Technical Note

Project:	Finchwood Park Parcels 11 & 12	SMA Ref:	7292.TN08
Subject:	Response to WBC Highways Comments	Revised:	B – 16.10.2025
Prepared by:	Tyler Andrews	Date:	06.08.2025
Checked by:	Kate Marshall	Date:	07.08.2025

This Technical Note (TN) has been prepared by Stuart Michael Associates Limited (SMA) on behalf of Vistry Homes to address the comments received and information requested from the Local Highway Authority - Wokingham Borough Council (WBC) dated the 26th June 2025 on Application No: **250931**.

DRAWING TITLE: PARCEL 11 AND 12 ADOPTION PLAN SHEET 1 OF 2

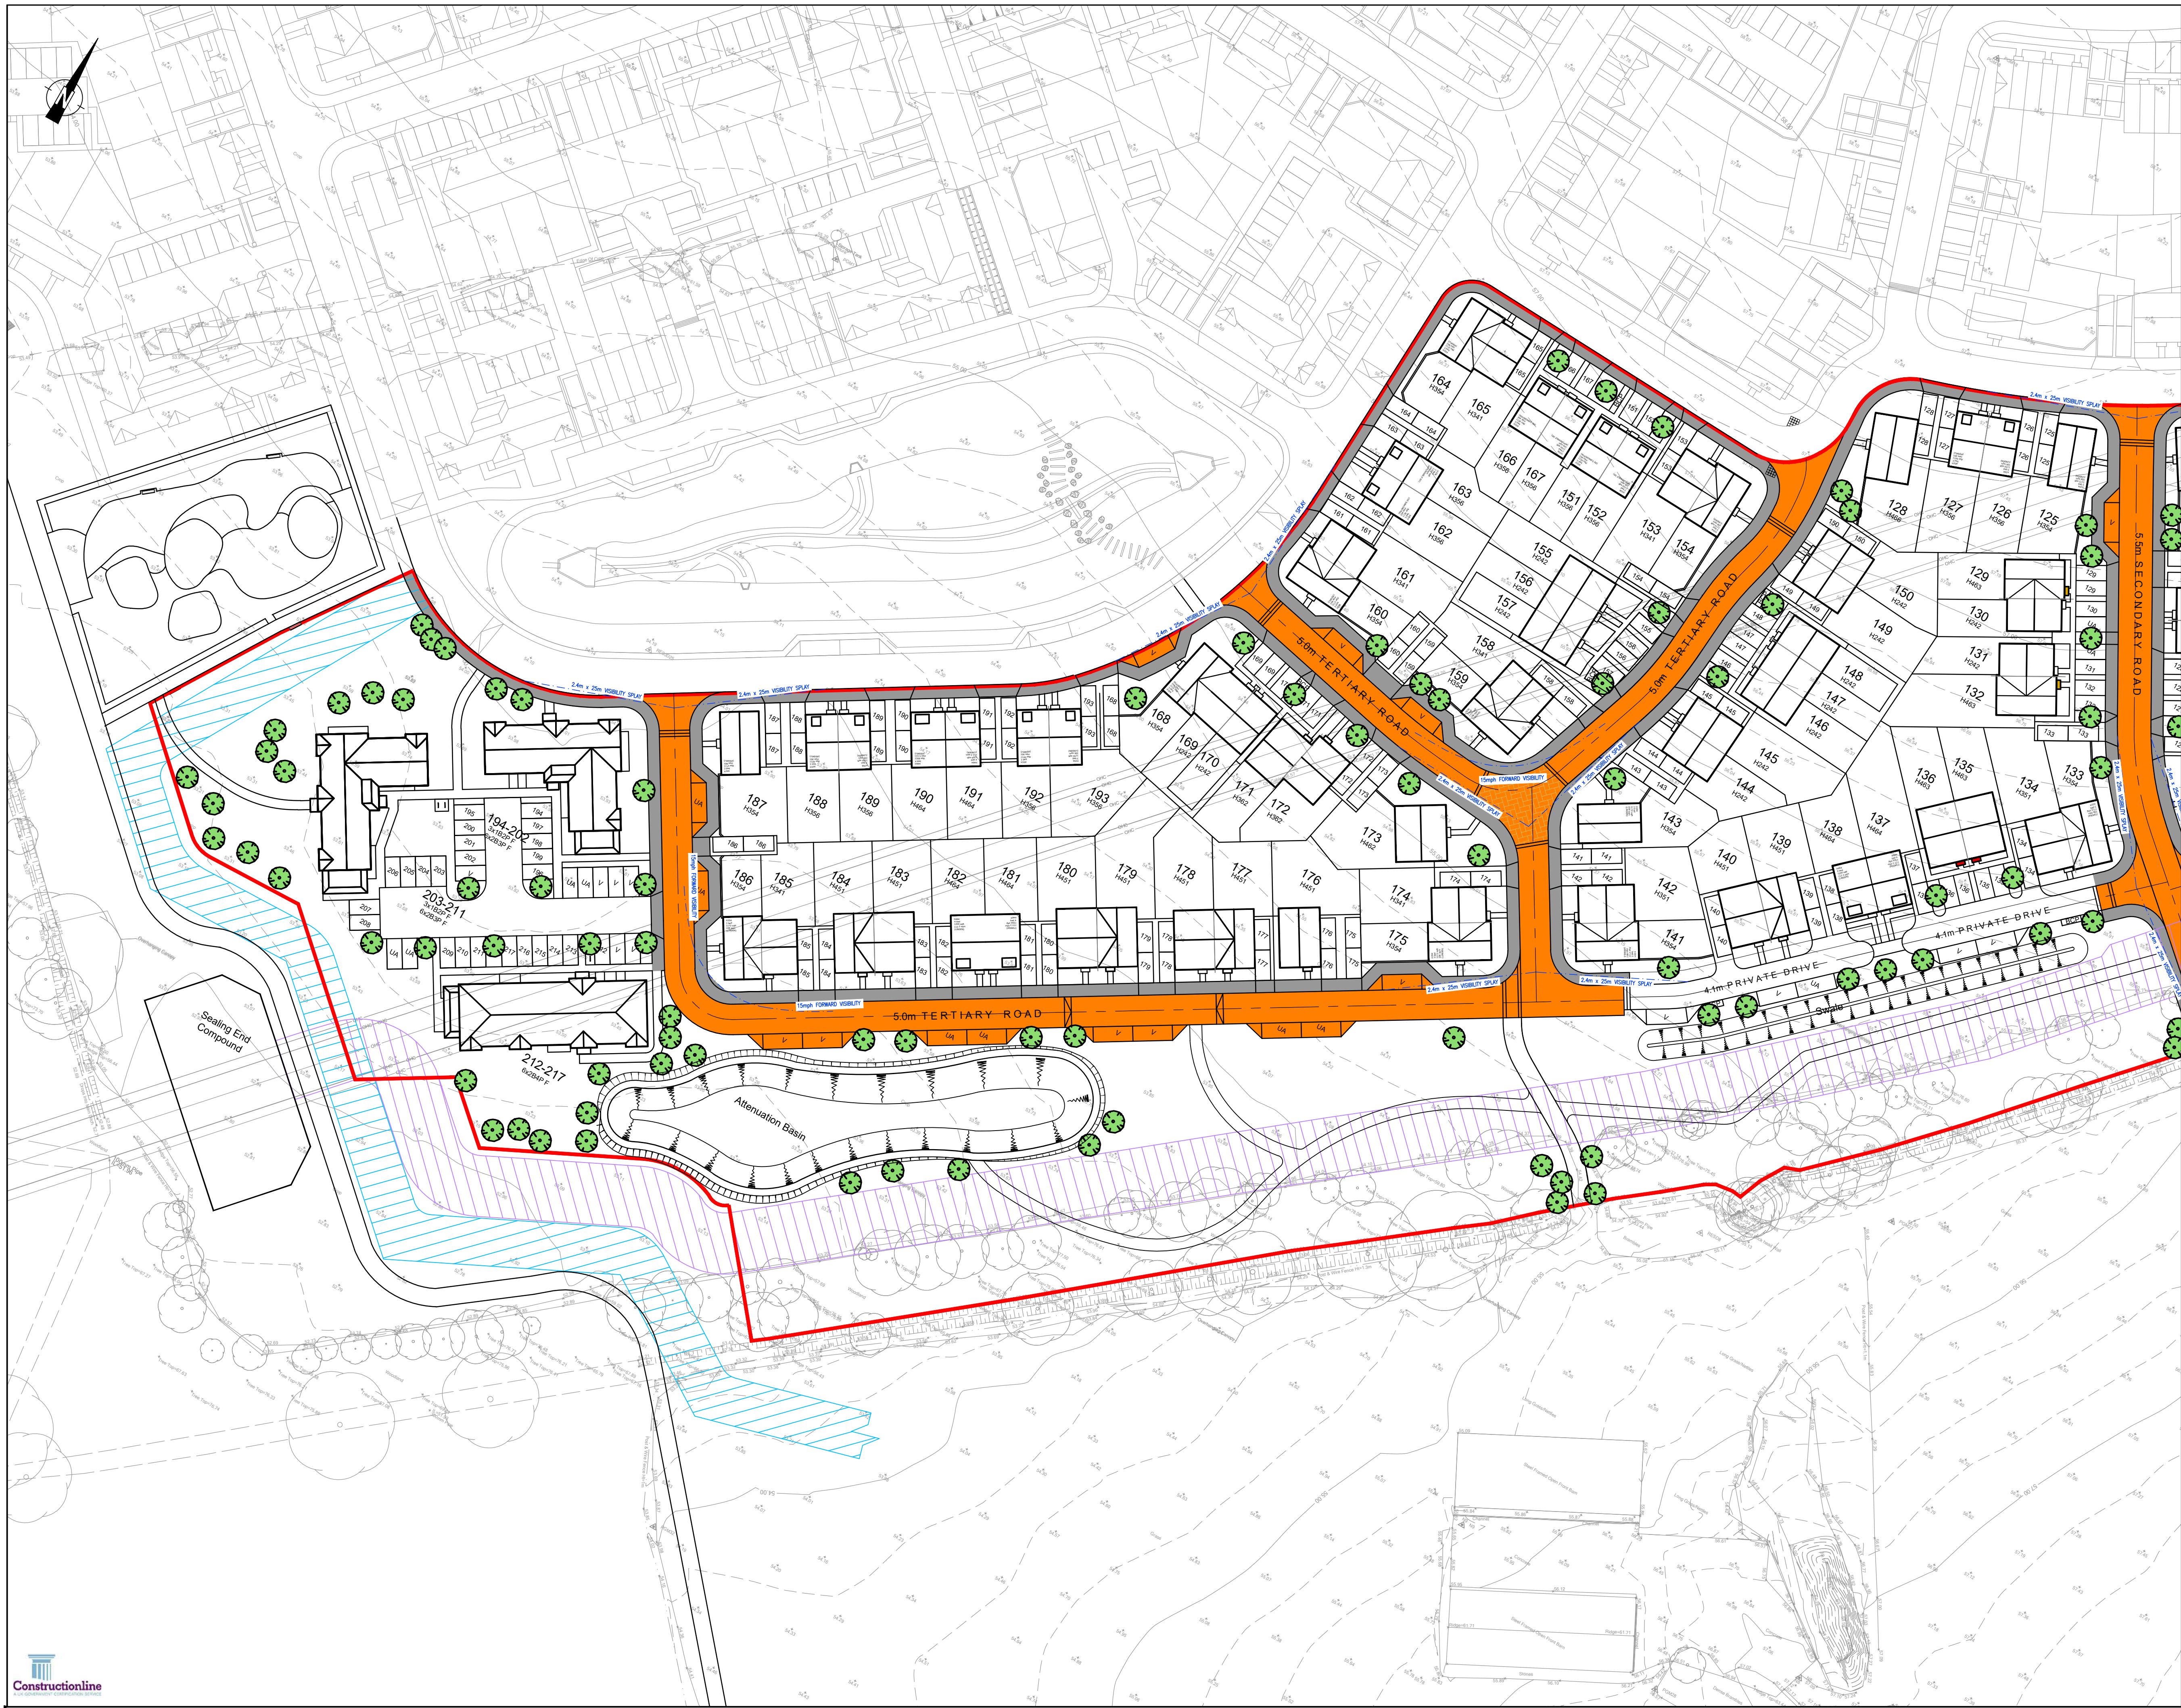
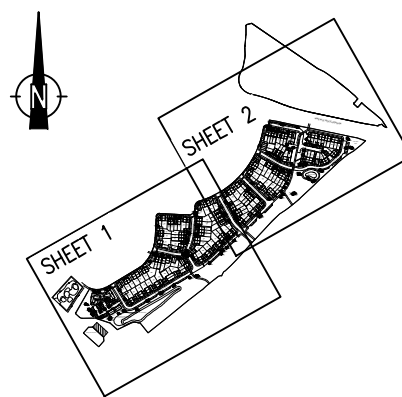
Furthermore, the 15mph visibility splay shown passes through land which is not offered for adoption as public verge/highway. Therefore, the 15mph visibility is not only substandard; but cannot be guaranteed given a fence could be erected within the splay. Screenshots highlighting the problem are provided below:

The proposed adoption plan has now been updated to ensure that any land within visibility splays is offered as part of the adoption process to the local authority. See extract below:

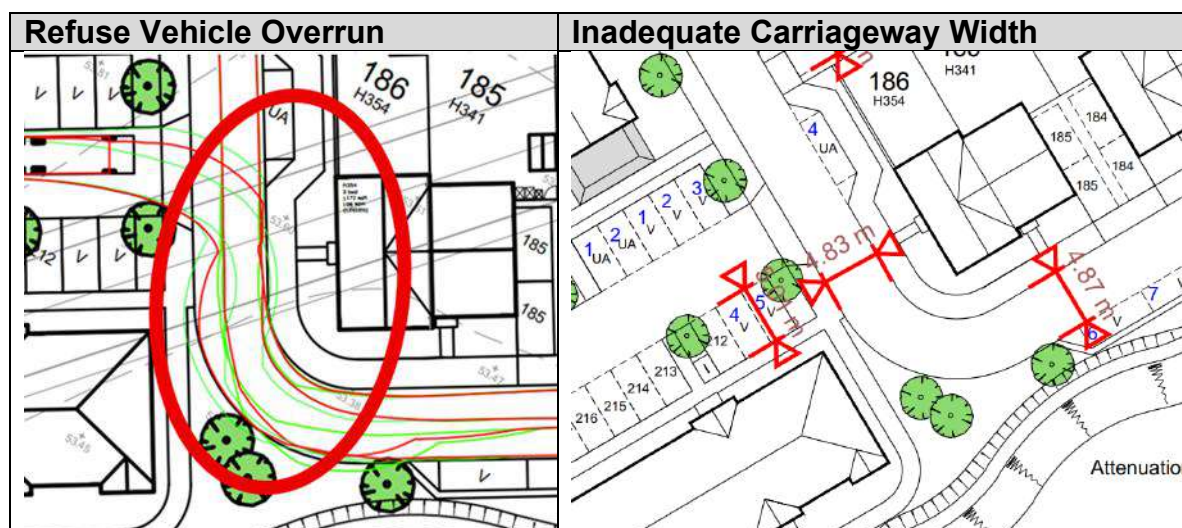
2. The LHA require the provision of physical speed reduction features between Plots 175 – Plot 186. This section of straight road is c.127m long and would result in vehicles exceeding the target speed of 20mph.
 - Features reducing vehicle speeds should be provided at 50-80m centres. Whilst this could take the form of traffic calming, good design should avoid the need for engineering features.
 - The design should naturally convey appropriate design speeds to drivers, with a target speed of 20mph specified in the Wokingham Living Streets

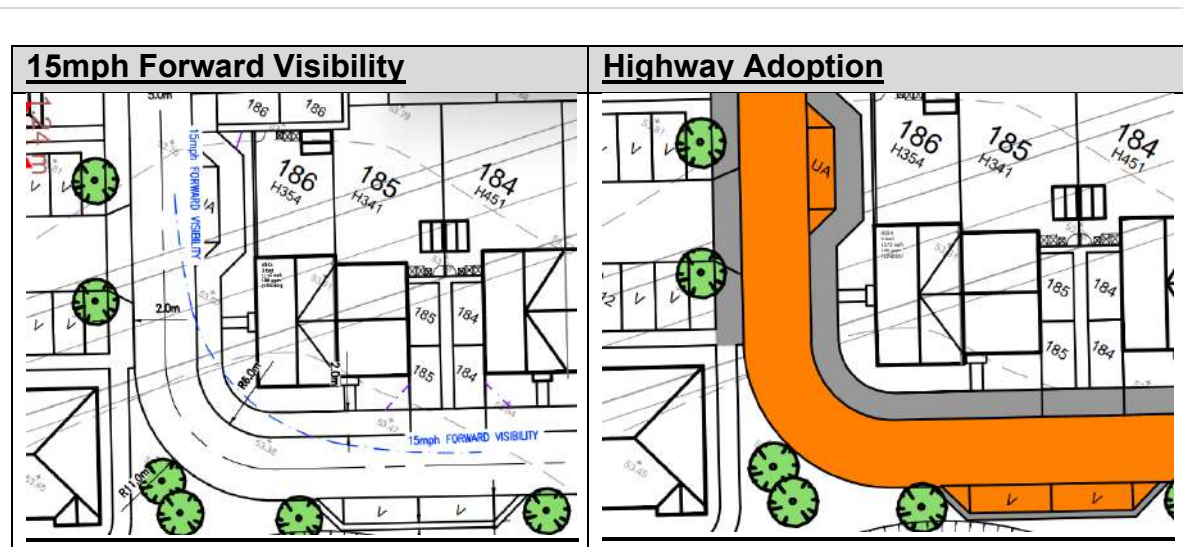
4. The swept paths for a refuse vehicle show that there are 3 areas where a refuse vehicle body and chassis would overrun the footway to the south-west of Plot 186.

5. The swept paths should show that a refuse vehicle and a large can pass each other (as per the preapplication advice provided by the LHA).
6. The LHA require the applicant to adjust the carriageway width, corner radii and provide amended swept paths which demonstrate a refuse vehicle will not overrun the footway and risk pedestrian safety. Measurements taken from the submitted site plan indicate that the carriageway width at this location is only 4.8m wide; rather than the 5.0m proposed and required by WBC.

7. Forward visibility of 25 metres should also be demonstrated around the bend for the 20mph speed limit, as only a 15mph visibility has been shown. The LHA are concerned that without suitable passing space and without suitable forward visibility there could be conflicts between refuse vehicles and cars travelling around the bend. Screenshots of the refuse vehicle overrun and measurements of carriageway width are provided below.

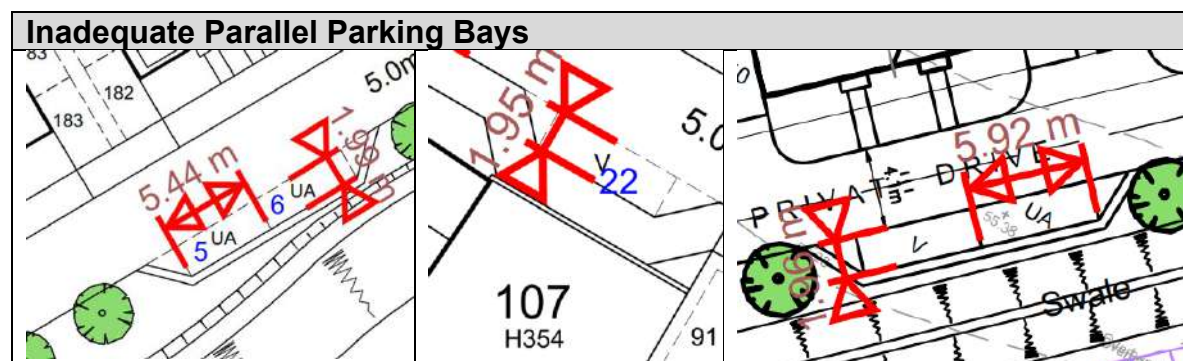
11. The parallel visitor spaces do not meet WBC dimensions and only measure 5.4m – 6.0m long x 1.91m – 2.0m wide. The WBC Parking Standards require *'Where spaces are parallel to the aisle or access road they should be 6.5m in length and 2.5m in width'*

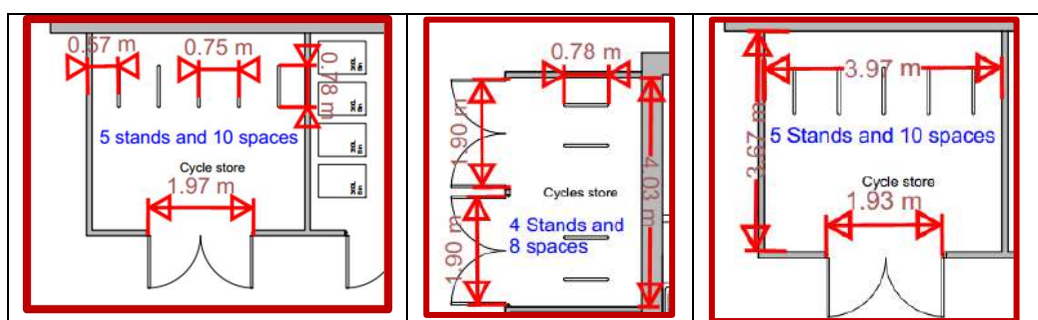
12. The LHA require the applicant to confirm the method of entry to the cycle store (i.e. swipe card or pin pad), provide sliding doors instead of swing doors

to improve ease of access and confirm the provision of lighting and CCTV for the store. The WBC Parking Standards refer to Sustrans sheet FF37 which identifies these features as a good cycle store design.
